**Service Bulletin No. SB-AG-30**

**1 October 1992**

**Revised 1 May, 1993**

### SPAR CRACKS UNDER AILERON BRACKETS

FIGURE 1

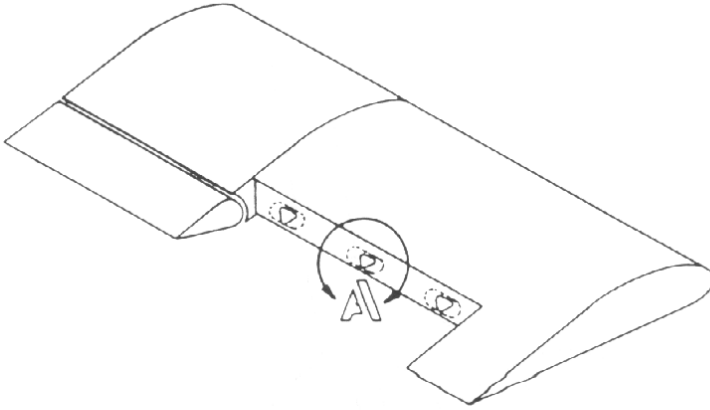
1. Remove aileron.
2. Gain access to the closed bay just forward of the aileron by:
  - a. Enlarging the access holes in the aileron cove skin as shown in Figure 1.

FIGURE 2

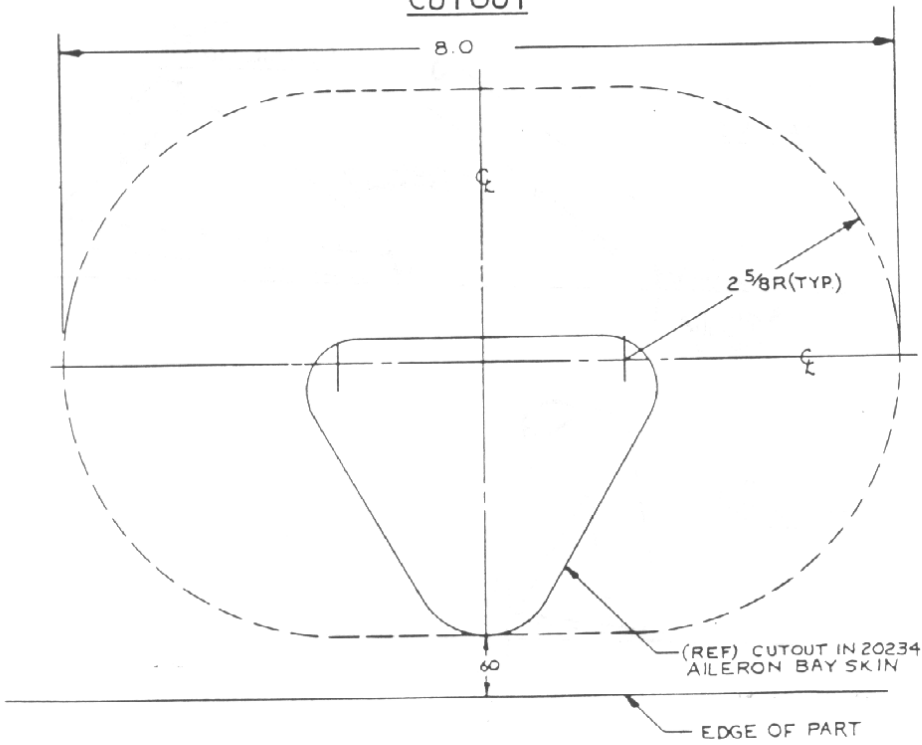
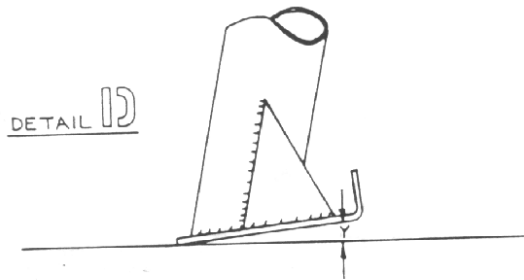
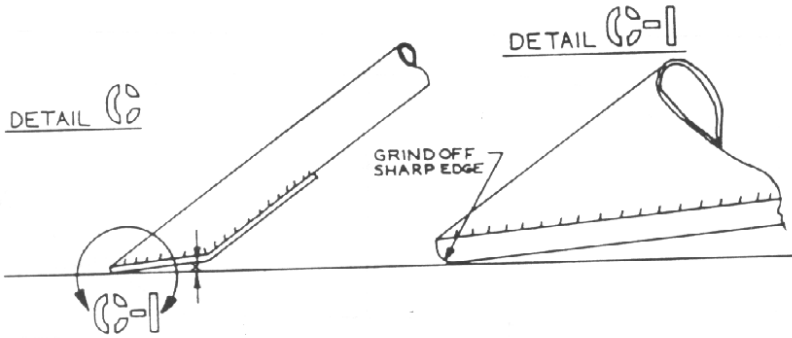
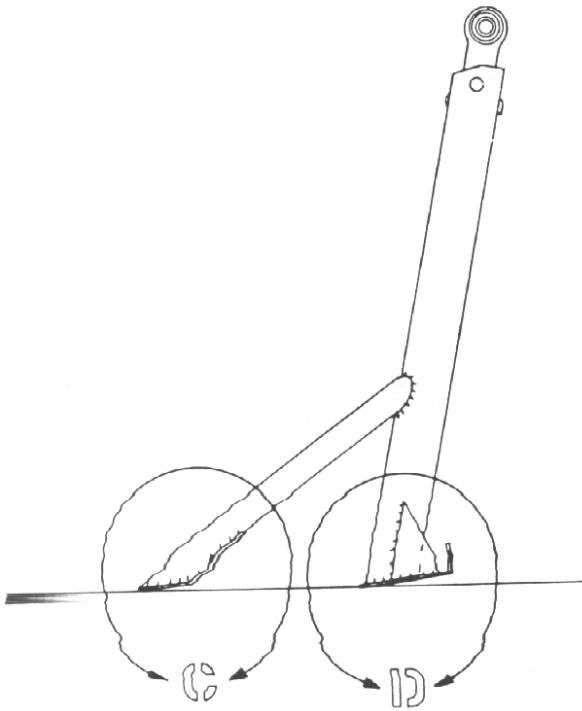
3. Remove P/N 52169 aileron brackets, three per side.
4. Using a flat surface, inspect the aileron bracket pads as shown in Figure 2. For reuse, the "X" and "Y" dimensions must not exceed .020 inches. (For brackets that are slightly out of tolerance, it may be possible to straighten the "X" dimension pad by light bending to achieve the required tolerance. Do not bend the legs of the brackets, only the pads.) If the brackets cannot be reworked to pass this check, order new brackets from your dealer. If the old brackets are to be reused, chamfer(round off) the edges of the upper pads as shown in Figure 2, Detail C-1.

FIGURE 3

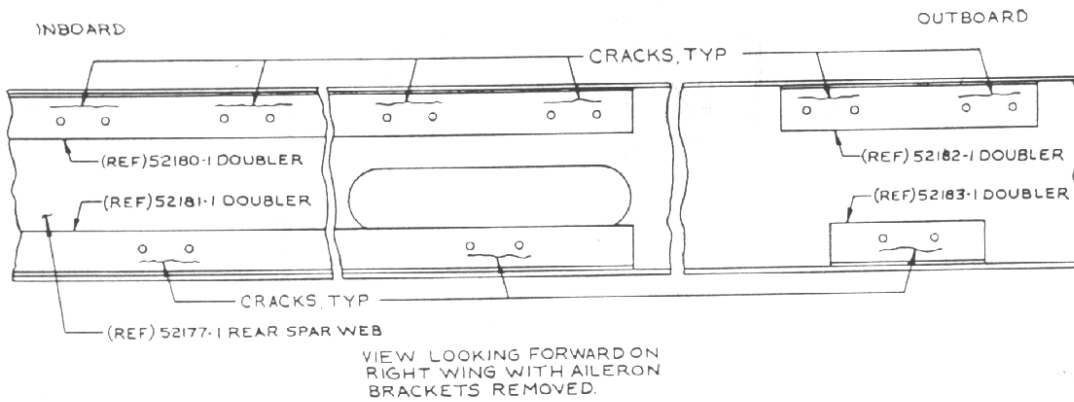
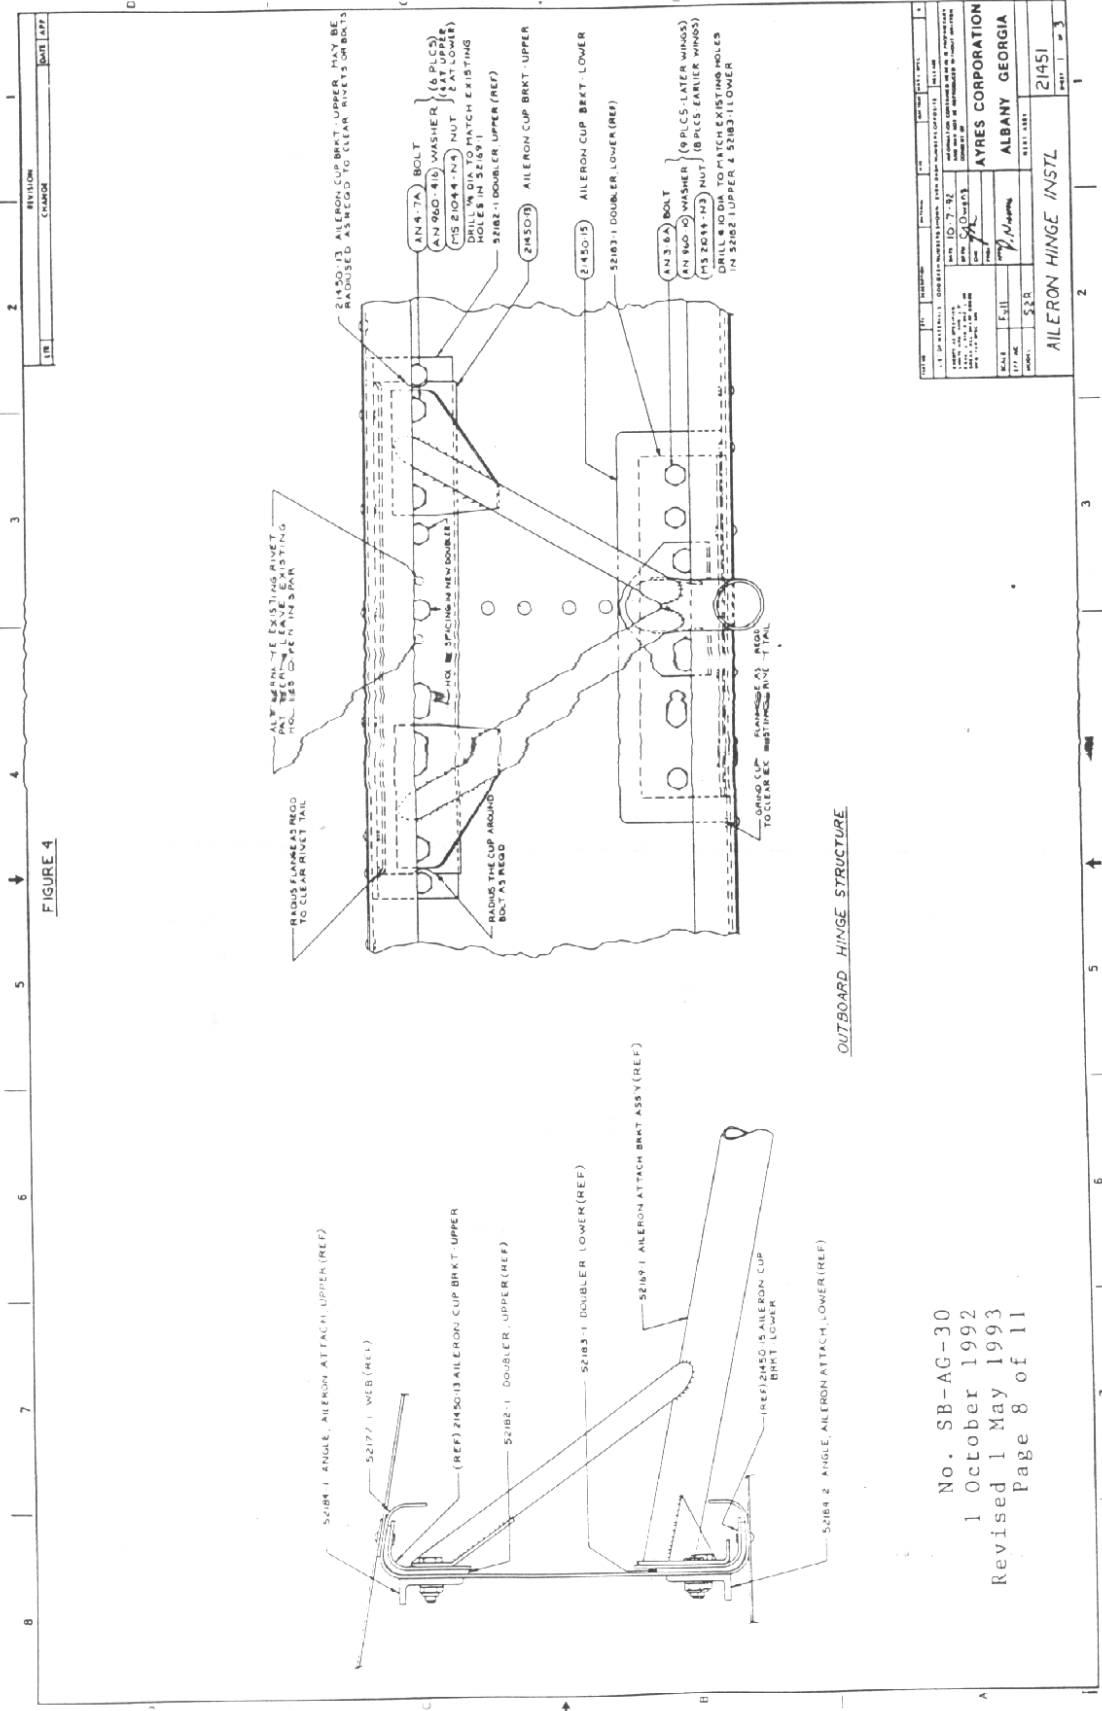
1. Inspect for cracks in the doublers, P/N 52182-1 upper and 52183-1 lower. If no cracks are found, install a new (or inspected and reworked) aileron bracket. Go to step III-1.
2. If cracks are found in these doublers, remove and discard them. Inspect the underlying spar web, P/N 52177-1, for cracks. If no cracks are found in the spar, install new doublers, cup brackets\*, P/N 21450-13 upper and 21450-15 lower, and the aileron bracket. Go to Step III-1.

3. If cracks are found in the underlying spar web, remove the extruded angles, P/N 52184-1 upper and 52184-2 lower, on the forward face of the spar and stop drill the web.
4. Reinstall angles, new doublers, cup brackets and a new (or reworked) aileron bracket. Go to Step III-1.

- NOTES (1) IF THERE IS ANY QUESTION REGARDING THE EXISTENCE OF A  
CRACK, USE A DYE PENETRANT TO AID THE INSPECTION.
- (2) STOP DRILL ALL CRACKS NO. 50.

FIGURE 4.

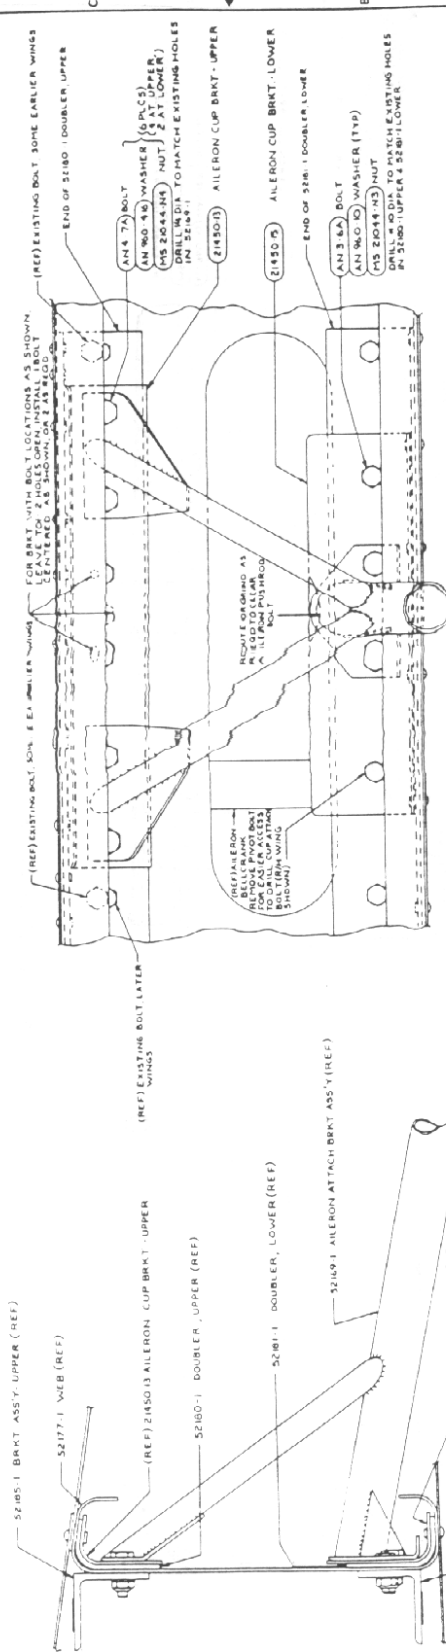
1. Inspect for cracks in the doublers, P/N's 52180-1 upper and 52181-1 lower. If no cracks are found, install a new (or inspected and reworked) aileron bracket. Go to Step IV-1.
2. If cracks are found in these doublers, remove the angle brackets, P/N 52185-1 upper and 52187-1 lower, forward of the spar and inspect the spar web from its front side. If cracks are found in the spar, stop drill these cracks from the front side. Stop drill the doublers from the aft side of the spar. Reinstall the angles, together with the cup brackets\* and a new or reworked aileron bracket. Go to Step IV-1.

NOTE: If the two center bolts between the aileron brackets attach pads are too close to the radius of the cup brackets, leave the existing two holes open and drill one hole in the center, low enough to clear the radius. Ref. Drawing 21451, sheet 2. Grind the center of the bottom cup flange as required to clear the aileron push rod/bolt.

**FIGURE 5**  
COVERPLATE ASSEMBLY  
AND INSTALLATION

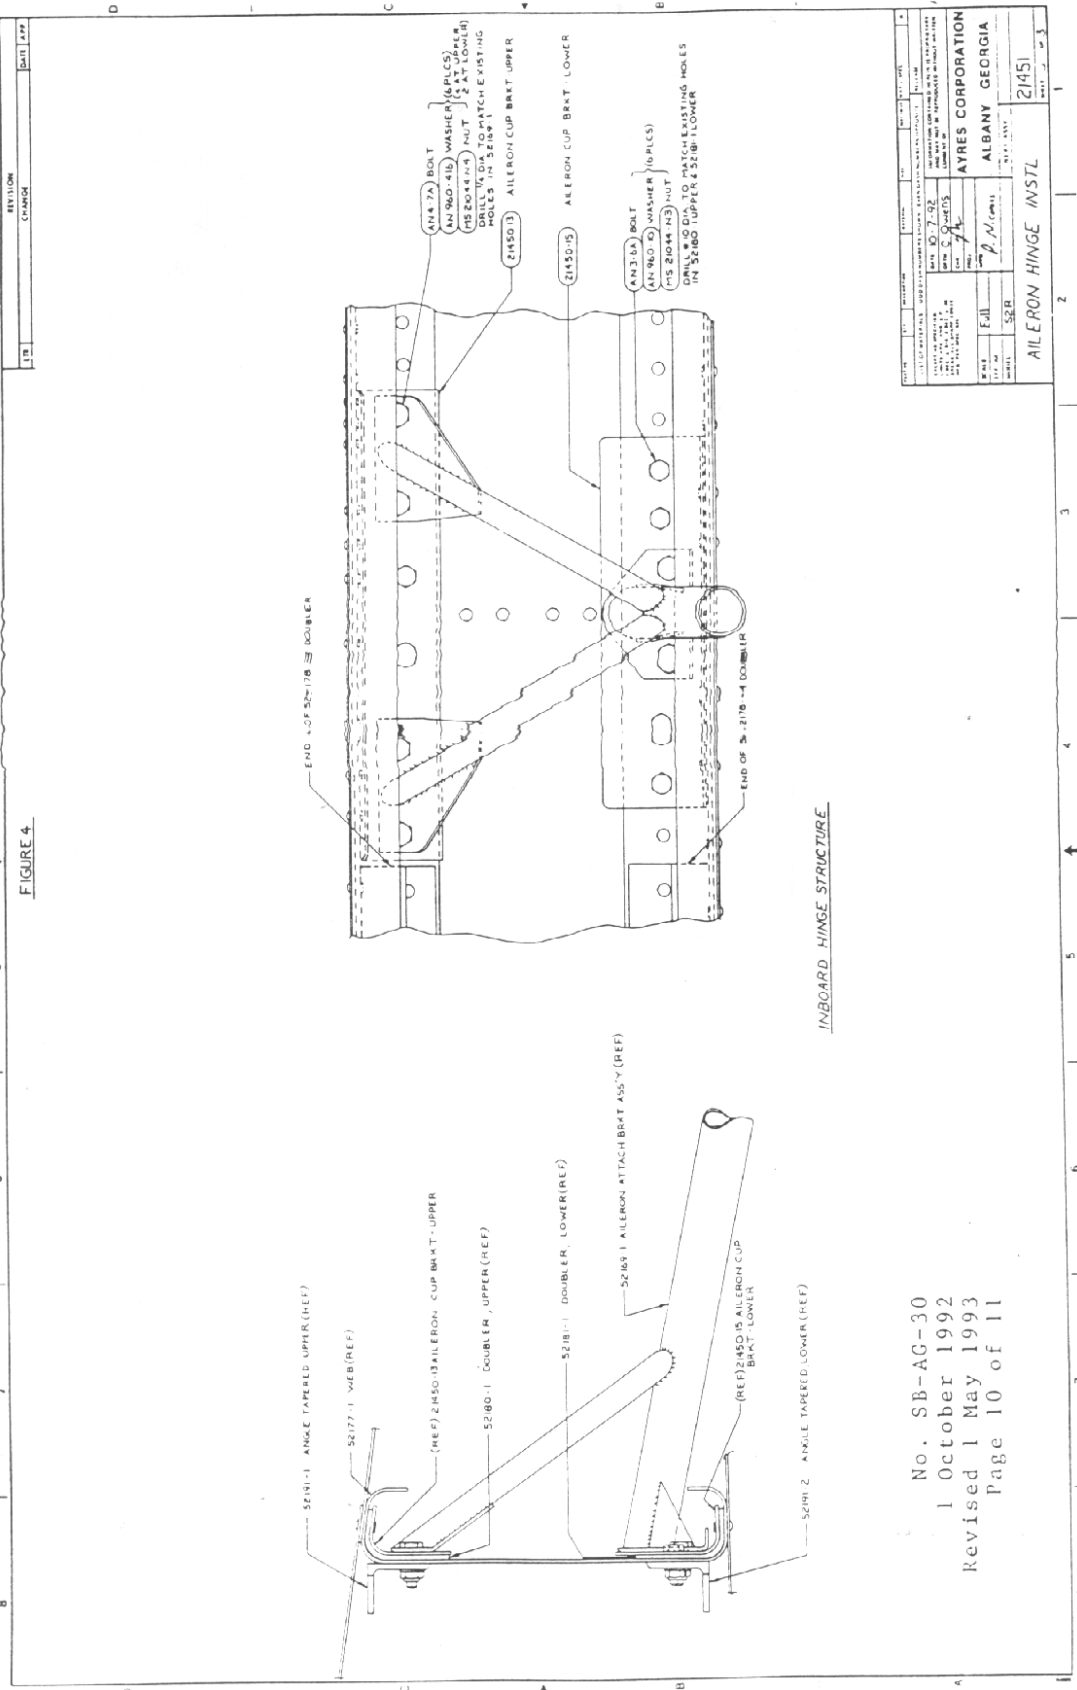
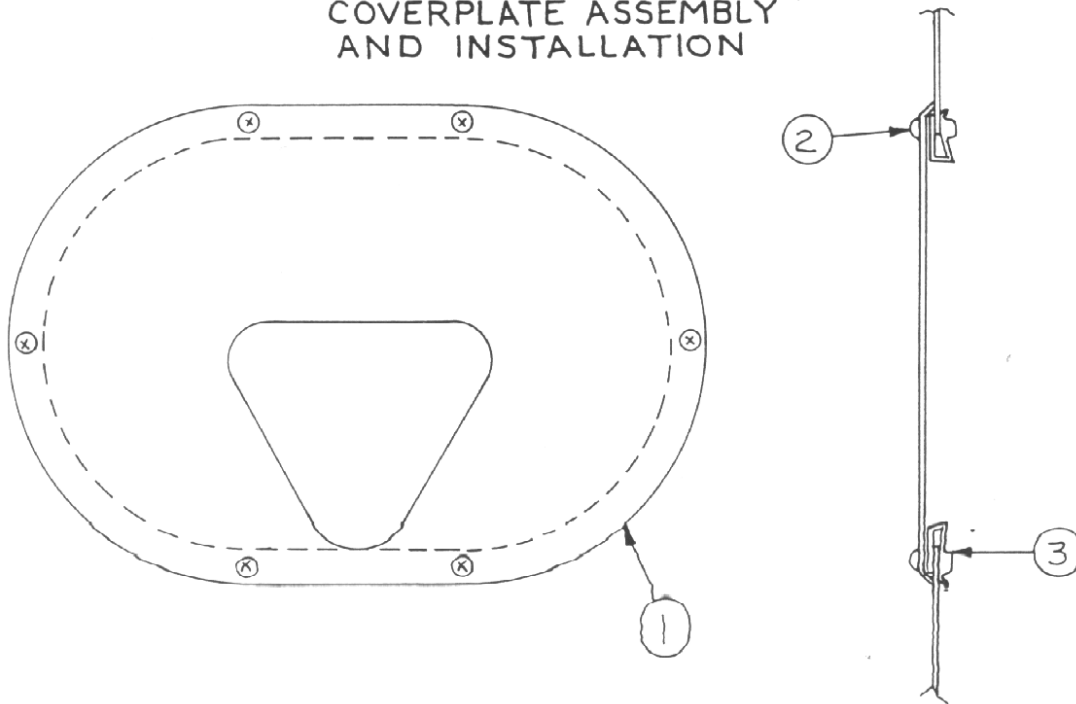
- V. Close out the enlarged access holes in the aileron cove skin as shown in Figure 5. Parts may be fabricated on site or purchased from your dealer. Or, alternately, reinstall the peeled down cove skin if this method of access was used.
